Access Compliance Report

Public Rights-of-Way

(Pedestrian Signals)

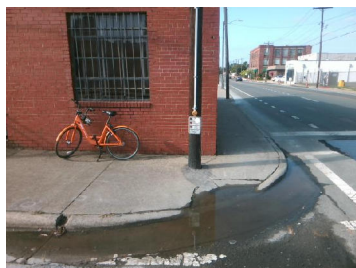
PROW/ADA: R404.2, R404.3

Possible Solutions: Remove and Replace Clear Space.
